DEPARTMENT OF JUSTICE

28 CFR Part 36

Nondiscrimination on the Basis of Disability by Public Accommodations and in Commercial Facilities; Correction

ACTION: Proposed rule; correction.

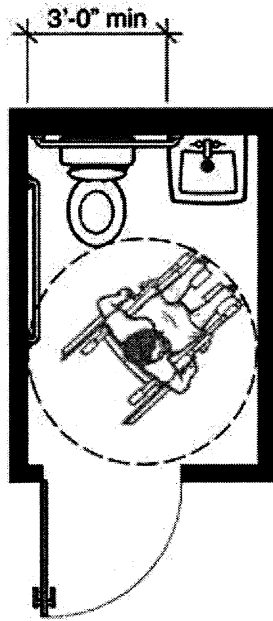
Water Closet Clearance. Proposed section 604.3 represents a change where a lavatory is installed adjacent to the water closet. The 1991 Standards allow lavatories to be placed 18 inches minimum from the water closet centerline, which precludes side transfers. To allow greater transfer options, the proposed standards

Commenters urged the Department not to adopt section 604.3 claiming that it will require single-user toilet rooms to be two feet wider than the requirements now provide, and this additional requirement will be difficult to meet.

The requirements at section 604.3.2 specify how required clearance around the water closet can overlap with specific elements and spaces. An exception, that applies only to residential dwelling units, permits a lavatory to be located no closer than 18 inches from the centerline of the water closet. The requirements at section 604.3.2 increase accessibility for individuals with disabilities.

Plan-1A: 1991 Standards Minimum with Out-swinging Door

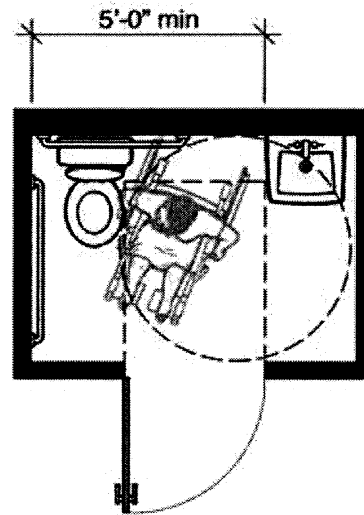
This plan shows a typical example of a single-user toilet room that meets the minimum requirements of the 1991 Standards. The size of this space is determined by the minimum width required for the water closet and lavatory between the side walls, the minimum wheelchair turning space, and the space required for the out-swinging door. A lavatory with knee space can overlap the clear floor space required for the water closet provided that at least 36 inches of clearance is maintained between the side wall next to the water closet and the lavatory, see, 1991 Standards 4.17.3 and Fig. 28. A wheelchair turning space meeting section 4.2.3 of the 1991 Standards must be provided. The size of this room requires that the entry door swing out. The room would be larger if the door was in-swinging.

Plan-1B: 2004 ADAAG Minimum with Out-swinging Door

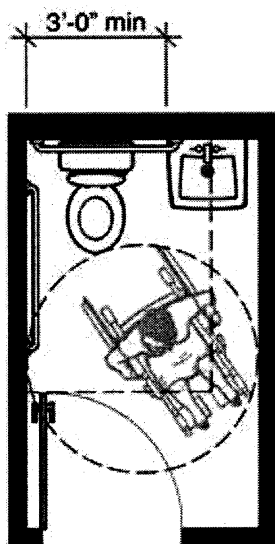
This plan shows a typical example of a single-user toilet room that meets the minimum requirements of the 2004 ADAAG. Features include: five foot minimum width between the side wall of the water closet and the lavatory; 60 inch minimum circular wheelchair turning space; and 36 inch by 48 inch clear maneuvering space for the out-swinging entry door. The 2004 ADAAG requires a floor clearance at a water closet that is a minimum of 60 inches wide by 56 inches deep regardless of approach, section 604.3.1. Except in residential dwelling units, no other plumbing fixtures can be located in this clear space, section 604.3.2. The 2004 ADAAG, at section 304.3, allows the turning space to extend into toe and knee space provided beneath fixtures and other elements, section 304.3. Required maneuvering space for the entry door (inside the room) must be clear of all fixtures. If the door had both a closer and latch then additional space would be required to the latch side, section 404.2.4.1 and Figure 404.2.1 (c). This layout is three point five percent (3.5%) smaller than the accompanying Plan-1A: 1991 Standards Minimum with Out-swinging

Plan-2A: 1991 Standards Minimum with In-swinging Door

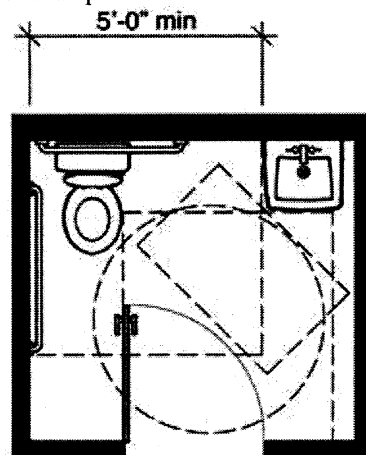
This plan shows a typical example of a single-user toilet room that meets the minimum requirements of the 1991 Standards. Depending on the width of the hallway and other circulation issues, it can be preferable to swing the entry door into the toilet room. Businesses and public entities typically prefer to have an in-swinging door. The in-swinging door increases overall room size because it cannot swing over the required clear floor space at any accessible fixture, 1991 Standards 4.22.2. This increases the room depth from Plan-1A. The door is permitted to swing over the required turning space shown as a 60 inch circle.

Plan-2B: 2004 ADAAG Minimum with In-swinging Door

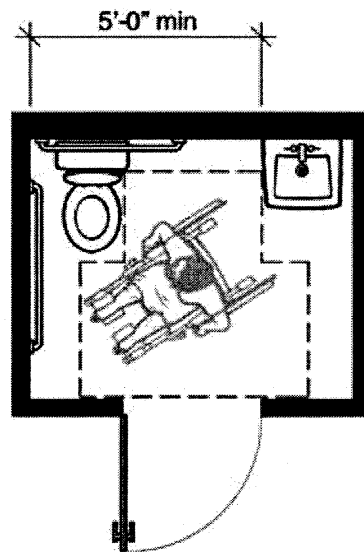
This plan shows a typical example of a single-user toilet room that meets the minimum requirements of the 2004 ADAAG when the entry door swings into the room. In the proposed standards an exception allows the entry door to swing over the clear floor spaces and clearances required at the fixtures if a clear floor space complying with section 305.3 (30 inches by 48 inches) is provided outside the arc of the door swing, section 603.3.3 exception 2. The required maneuvering space for the door, section 404.2.4.1 and figure 404.2.4.1(a), also is a factor in room size. This clear space cannot be obstructed by the plumbing fixtures. Note that this layout provides more space for turning when the door is closed than Plan-1B.

This layout is seven percent (7%) larger than the accompanying Plan-2A: 1991 Standards Minimum with in-swinging Door example.

**Comparison of Minimum Size Single-user Toilet Room “Pairs”
With Fixtures Side-by-Side**

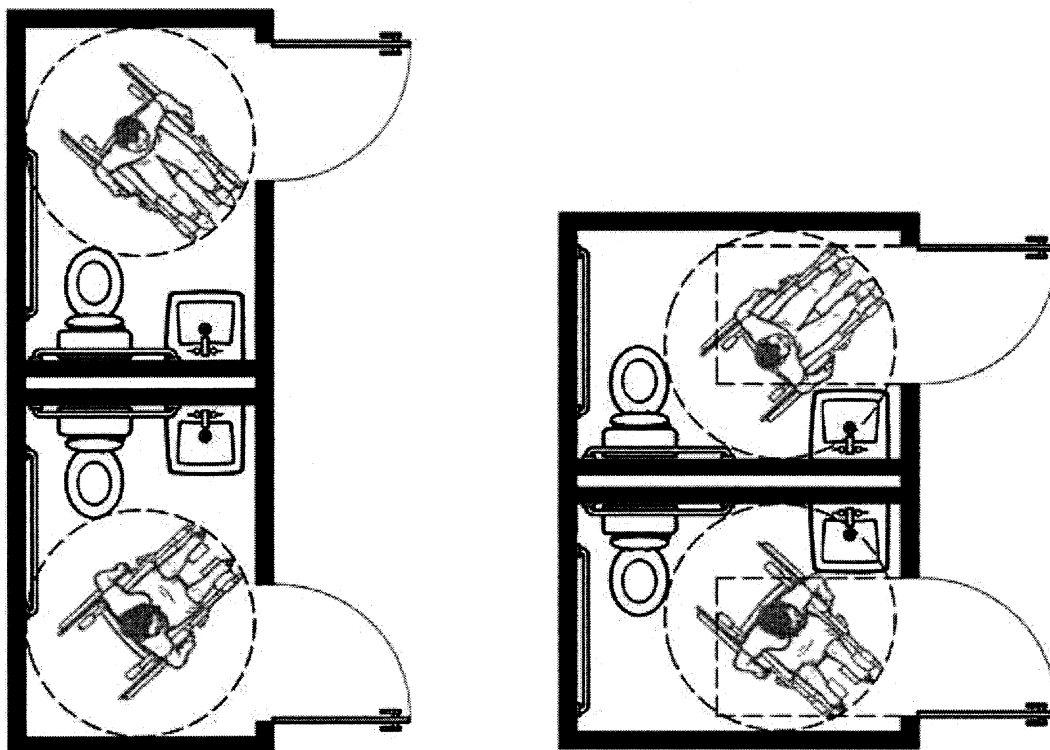
Above are a men's/women's room configuration comparison for Plans 1A and 1B.
